STAFF REFORT					
Address:	7417 Maple Ave., Takoma Park	Meeting Date:	2/2/2022		
<b>Resource:</b>	Contributing Resource Takoma Park Historic District	<b>Report Date:</b>	1/26/2022		
Applicant:	David Bend and Erin Mohan	<b>Public Notice:</b>	1/19/2022		
		Tax Credit:	No		
<b>Review:</b>	HAWP	Staff:	Michael Kyne		
Permit Number: 979104

# MONTGOMERY COUNTY HISTORIC PRESERVATION COMMISSION STAFF REPORT

**PROPOSAL:** Front porch alterations, construction of new rear addition, and fencing alterations

Fig. 6: 1927-63 Sanborn Fire Insurance Map, with subject property outlined in red.

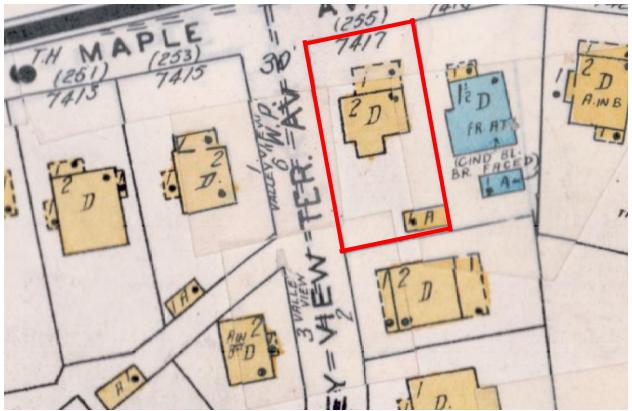
While there are no available photographs of the original front porch, the 1927-63 Sanborn Fire Insurance Map (see *Fig. 6*) depicts a one-story open front porch, which is justified to the left side of the house, whereas the existing front porch is centered on the front of the house. This demonstrates that the original front porch has either been significantly altered or replaced.
